Re: Watson Cogeneration Steam and Electric Reliability Project  
Application for Certification 09-AFC-1

# RESPONSES TO CEC REQUESTS FROM THE FEBRUARY 3, 2011 PSA WORKSHOP CONTINUATION APPLICATION FOR CERTIFICATION (09-AFC-1) for Watson Cogeneration Steam and Electric Reliability Project

**Responses to CEC Requests from the February 3, 2011 PSA Workshop  
Continuation**

**WATER BALANCE FLOW DIAGRAM**  
FIGURE 5.5-1 (Second Revision)

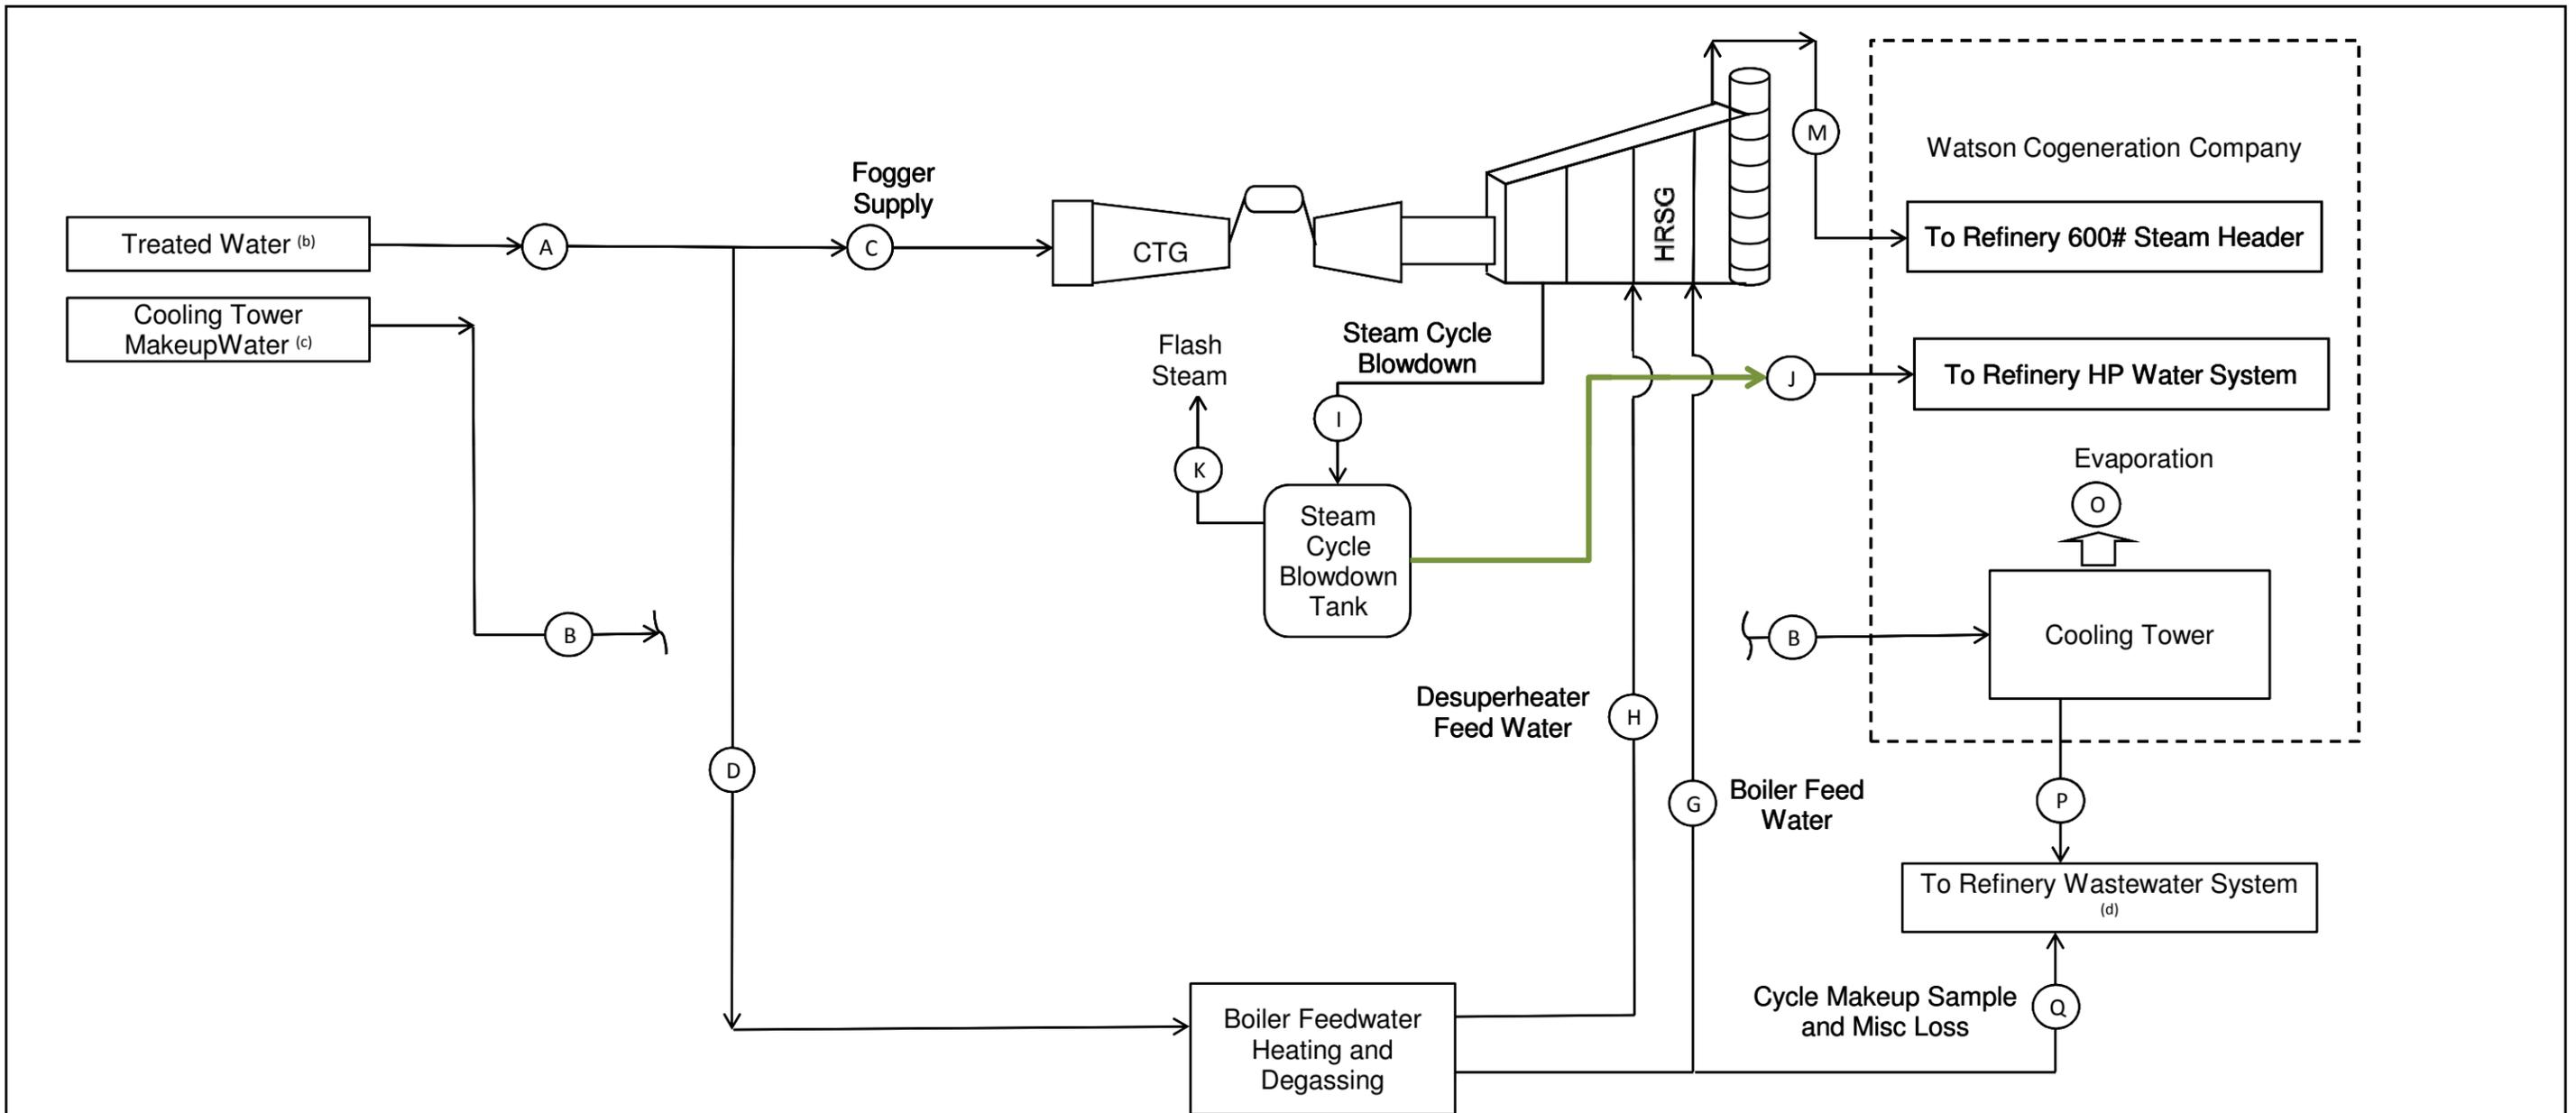
- 4. Water balance details for the existing 4-train plant and the proposed 5-train plant. This will help us to understand the volumes of water proposed for process, cooling, and steam/High Pressure water to the Refinery.***

Details of the Project's water supply, internal flows, and wastewater are provided in Revised Table 5.5-4 (Water Balance Flow Values) in the Revised Section 5.5 (see Attachment A). This table includes the volumes of water proposed for process, cooling, and steam/high pressure water to the BP Refinery for the Project. Second Revision Table 5.5-9 (Watson Water Sources and Uses/Wastewater Production) summarizes sources and uses of water for the existing, four-train Watson Cogeneration Facility and for the Watson Cogeneration Facility after the addition of the Project. To the extent CEC staff requests information related to the steam requirements of the BP Refinery, the Applicant maintains its objection as stated in the response to CEC Data Request Number 21, submitted on September 21, 2009.

The water balance diagram (Figure 5.5-1 [Second Revision], Water Balance Flow Diagram) shows process water flow streams for the Project. Revised Table 5.5-4, Water Balance Flow Values, shows the maximum daily, average daily, and average annual water supply and disposal flows. Water needs at the Project Site are considerably greater than those required by a combined cycle generating facility as the steam produced is provided for process use in the BP Refinery. As reflected in Figure 5.5-1 (Second Revision) and Revised Table 5.5-4, water use and wastewater production are reduced significantly through re-use of internal waste streams. Wastewater production rates are approximately 6 to 7 percent of the water supply.
